CPED STAFF REPORT

Prepared for the City Planning Commission
CPC Agenda Item #9
October 19, 2015
BZZ-7417

Project Name: Downtown East Phase III – Downtown East Commons

Request: To construct a new park.

PARK SUPPORT - PARK AVENUE ELEVATION

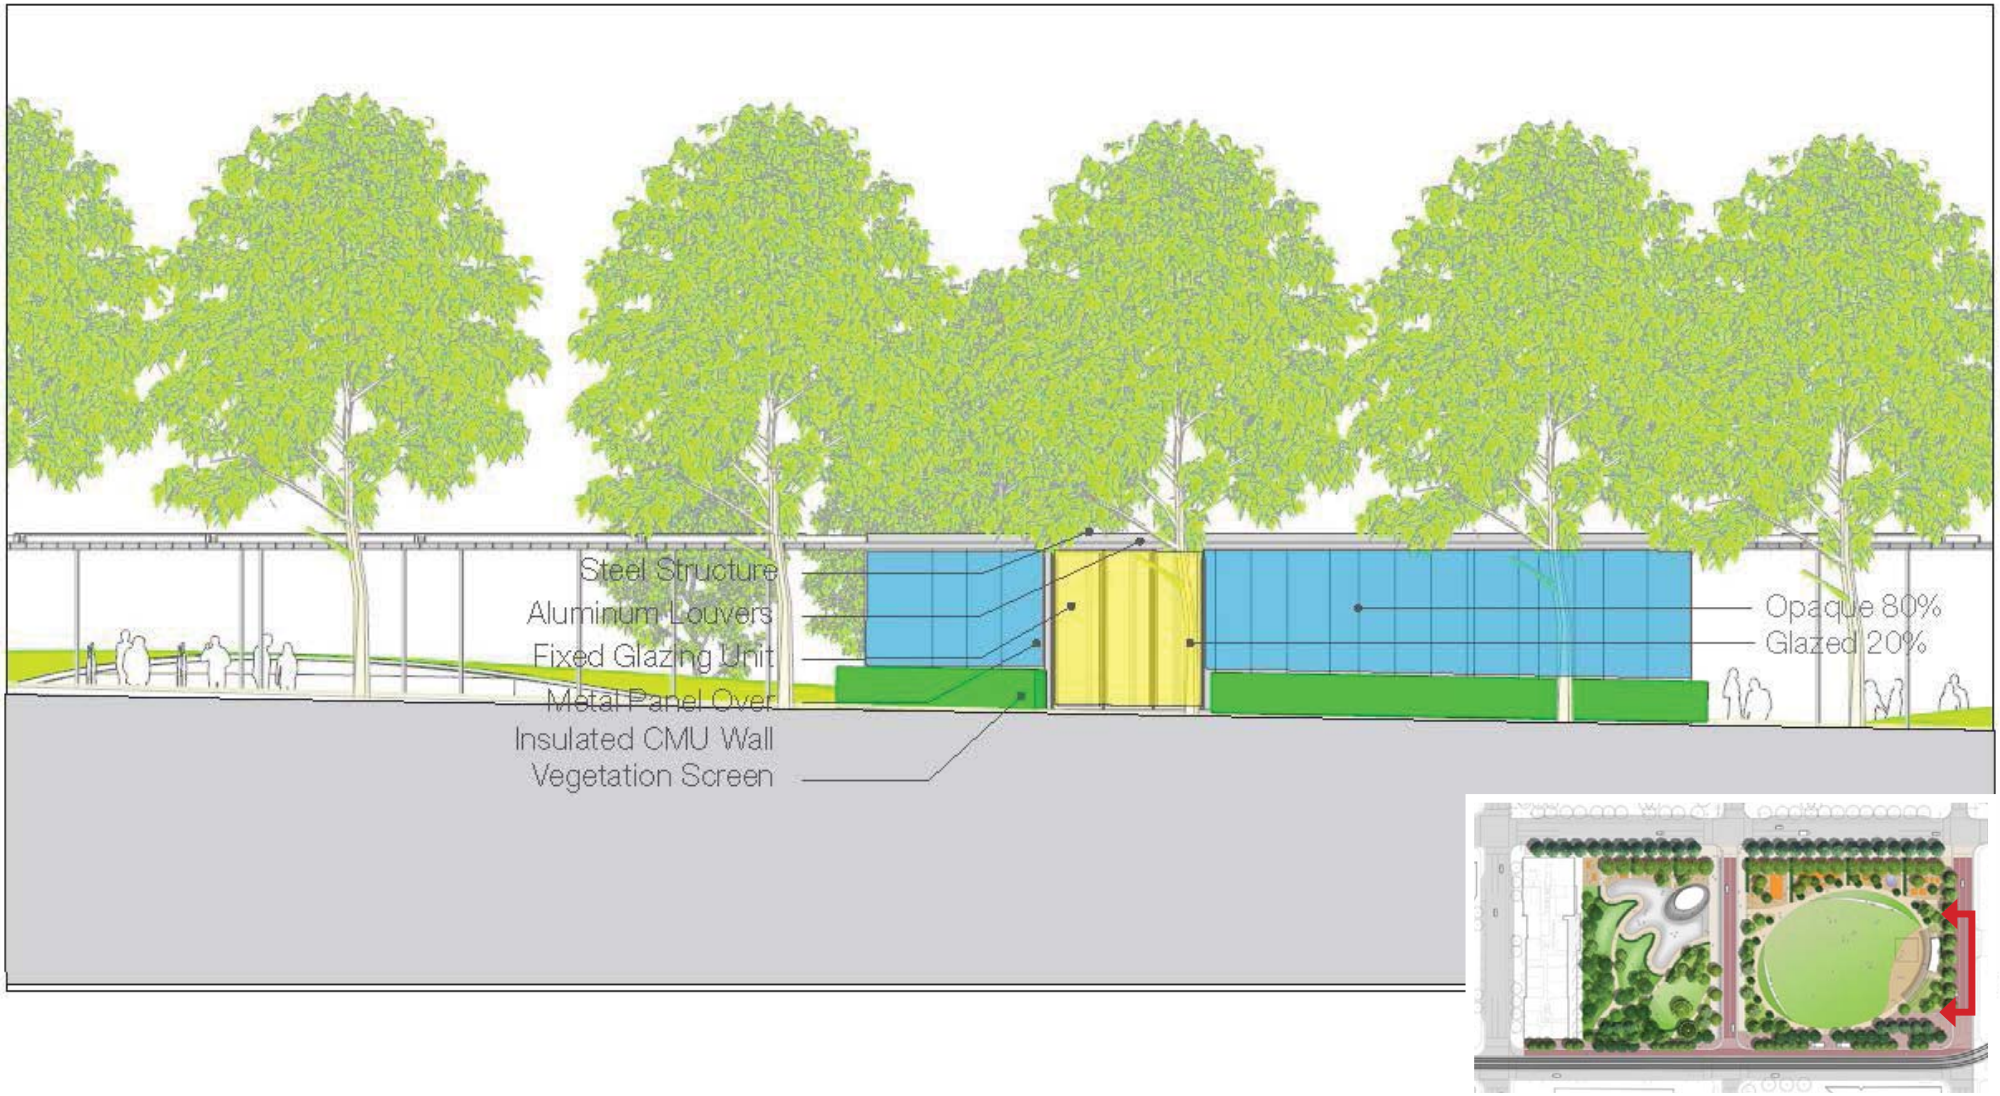
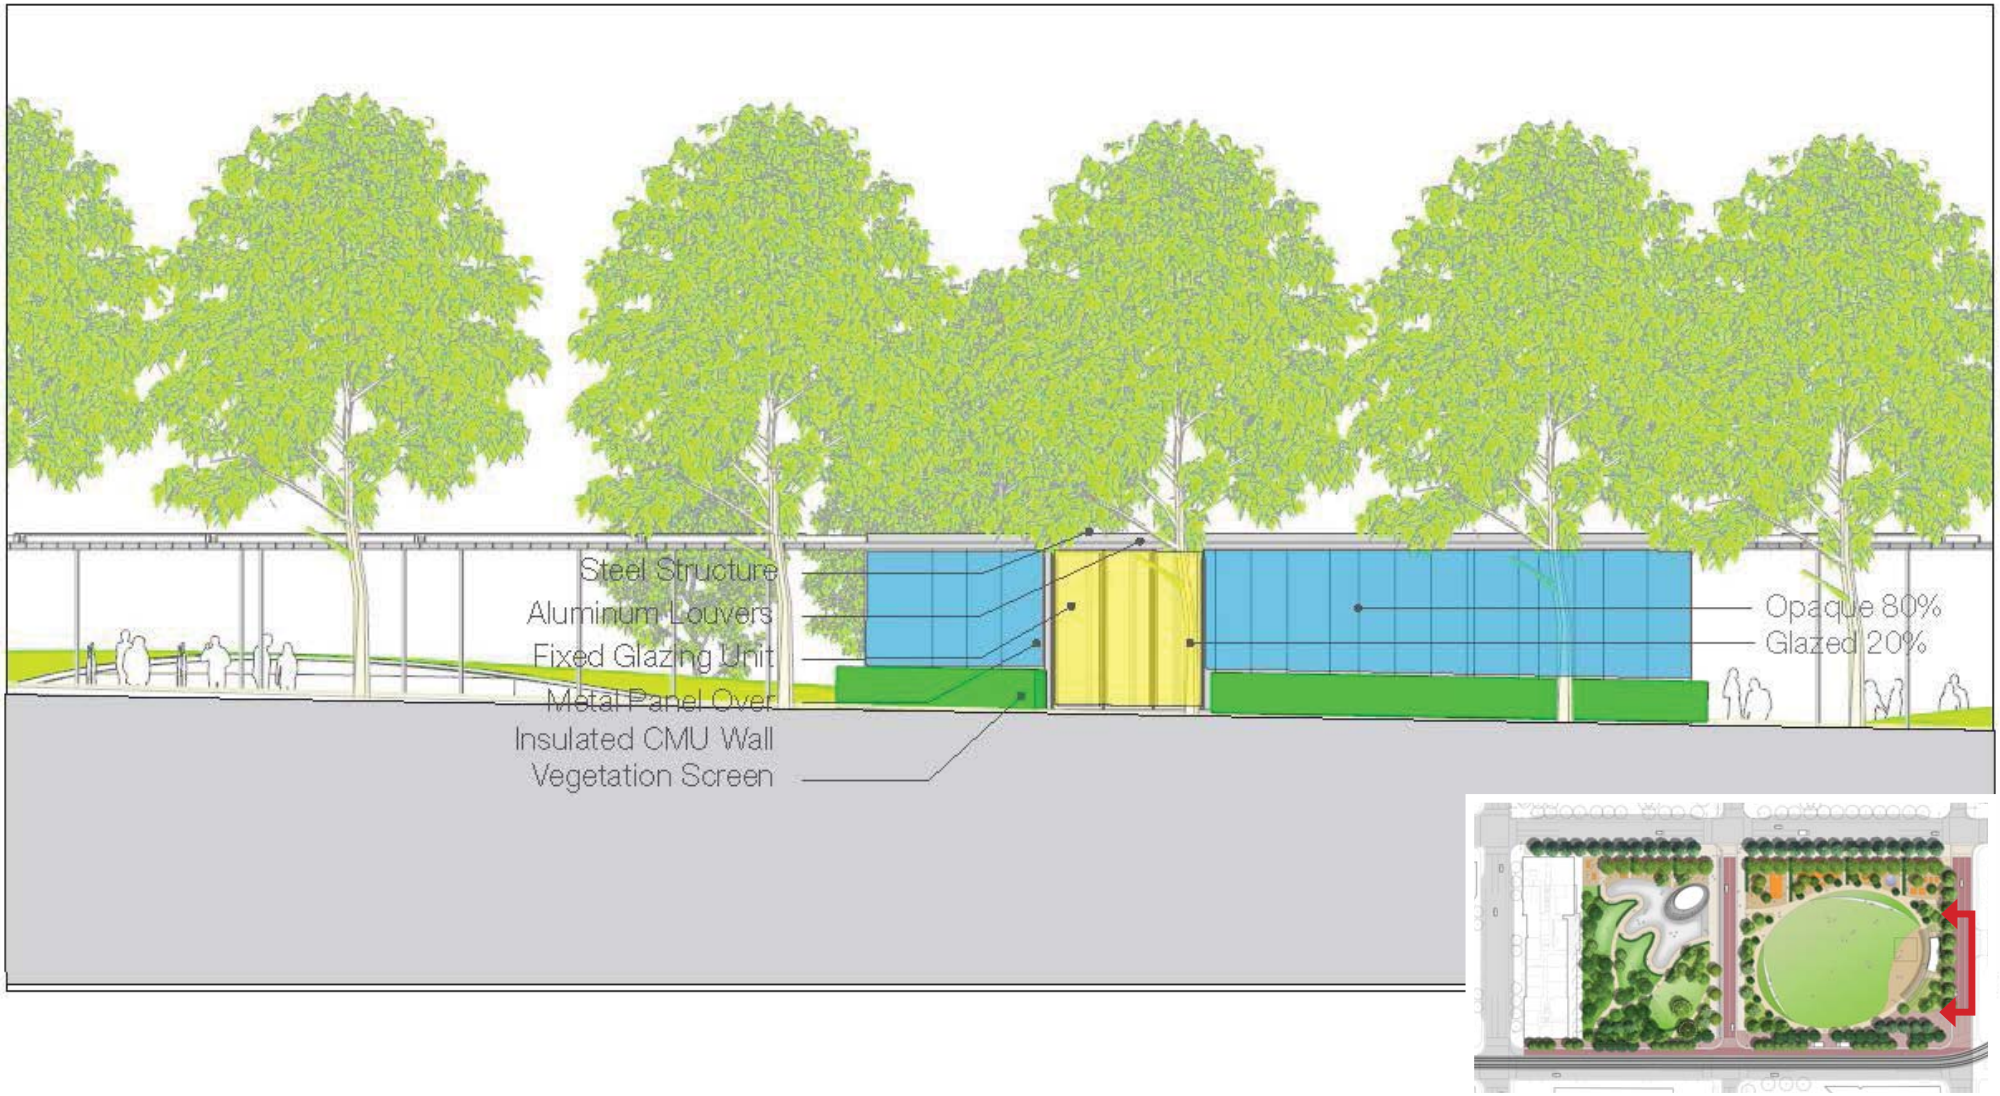
not meet the window requirement on the Park Avenue side of the building. In order to meet the blank wall requirement and to come closer to meeting the window requirement CPED is recommending that additional windows be added to both the west and east sides of the park support building.

- **Distribution of Windows (Park Support Building).** On the park support building the windows are concentrated in the middle of the building on both the west and east sides. The building does not meet the window requirement on the Park Avenue side of the building. In addition, there are areas on the west and east sides of the park support building that are over 25 feet in length and blank. CPED is recommending that additional windows be added to both the west and east sides of the park support building that are of a similar size as the rest of the windows in the building.

2. All site improvements shall be completed by October 19, 2017, unless extended by the Zoning Administrator, or the permit may be revoked for non-compliance.
3. All mechanical equipment shall be screened as required by the standards of Chapter 535, Regulations of General Applicability.
4. The final lighting plan shall conform to the standards of Chapter 535, Regulations of General Applicability.
5. Windows shall be added near the north entry and to the food preparation area that are of a similar size as the rest of the windows in the pavilion.
6. So there are no building walls over 25 feet in length and blank, additional windows shall be added to both the west and east sides of the park support building that are of a similar size as the rest of the windows in the building.
7. There shall be 25 percent windows on the Park Avenue side of the park support building.

PAVILION - FLOOR PLAN

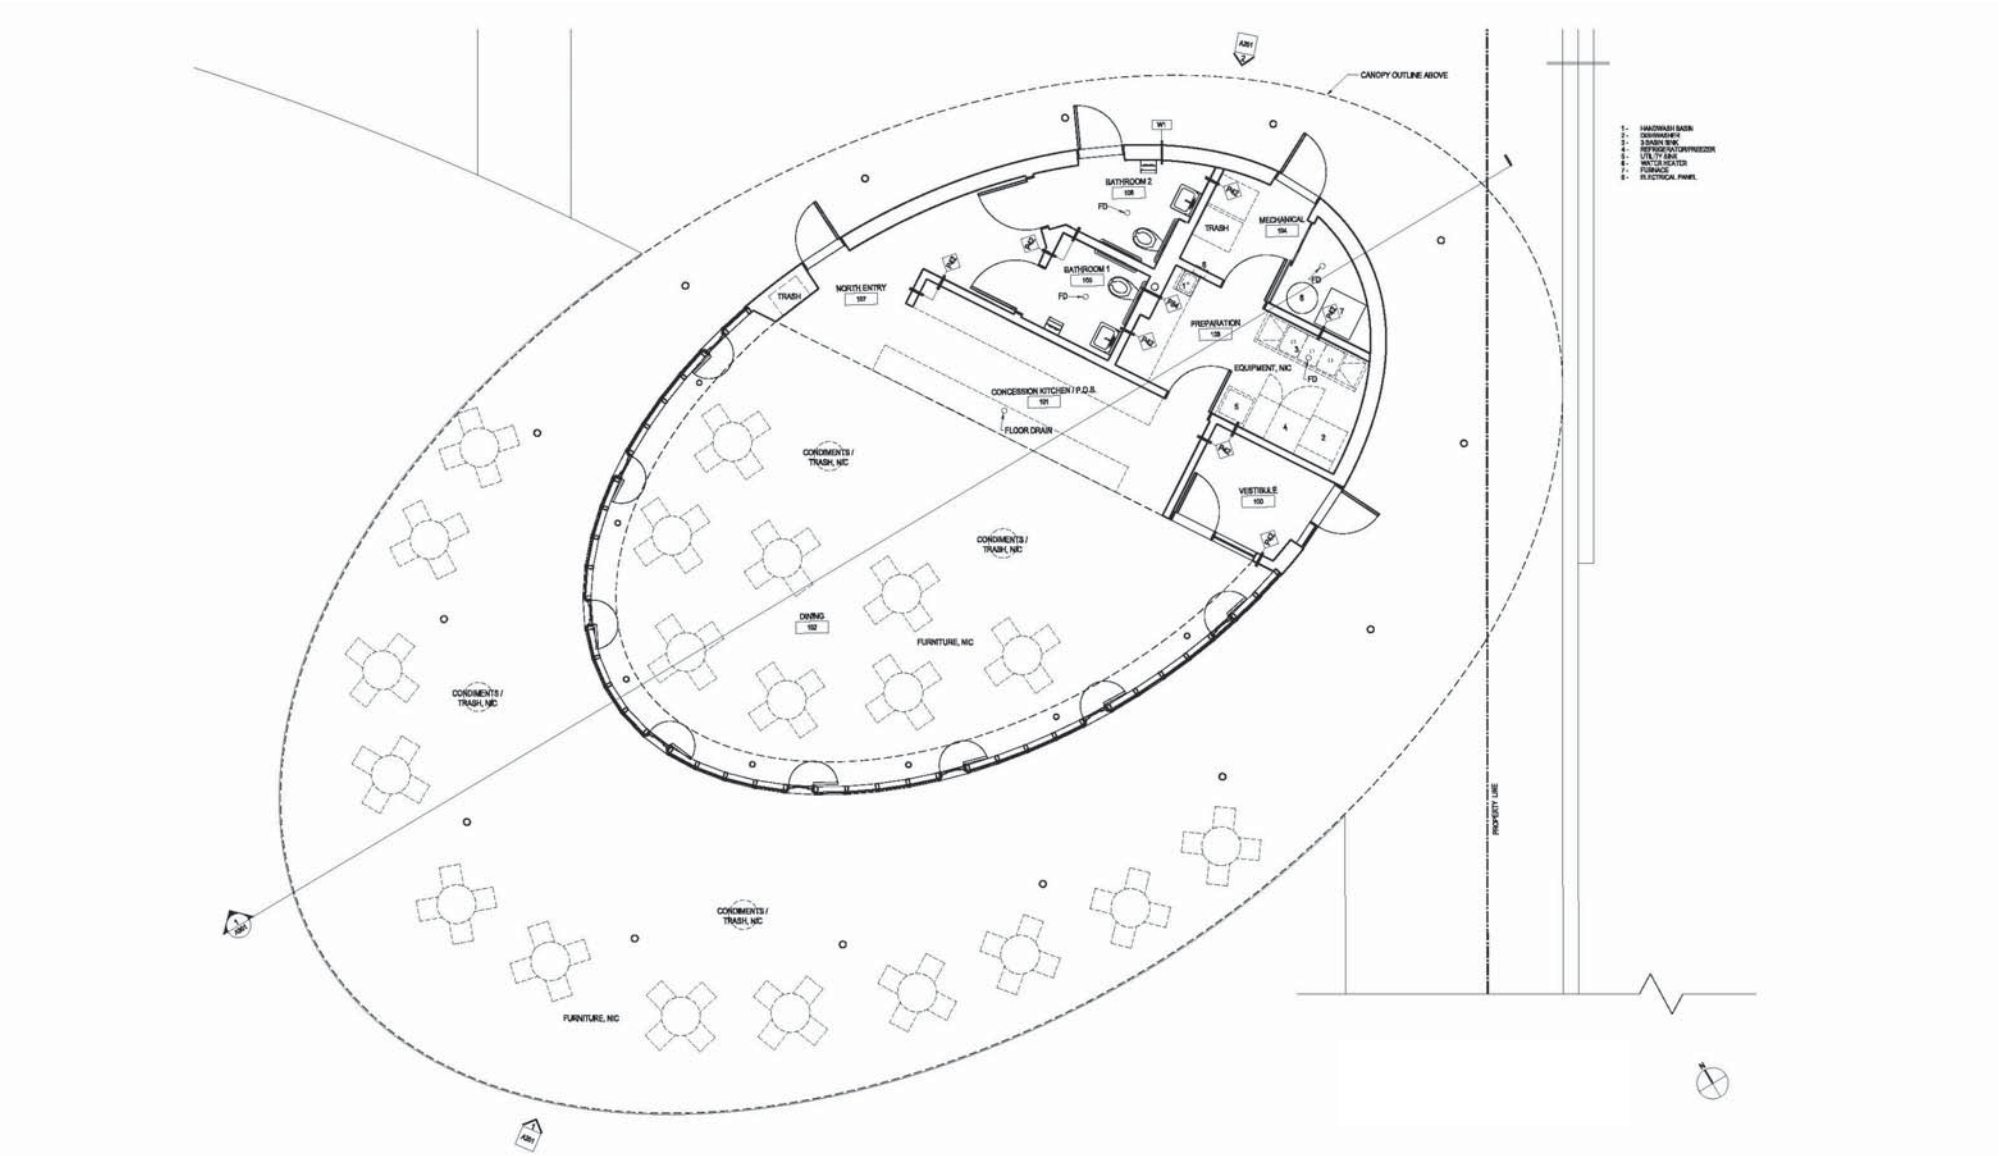
- **Distribution of Windows (Pavilion).** On the pavilion the windows are concentrated on the southerly portion of the building. The pavilion is shaped like an oval. On one end of the building are the restrooms, the mechanical room and the food preparation area for the café. On the other end of the pavilion is the seating area for the café. CPED is recommending that windows be added near the north entry and to the food preparation area that are of a similar size as the rest of the windows in the building.
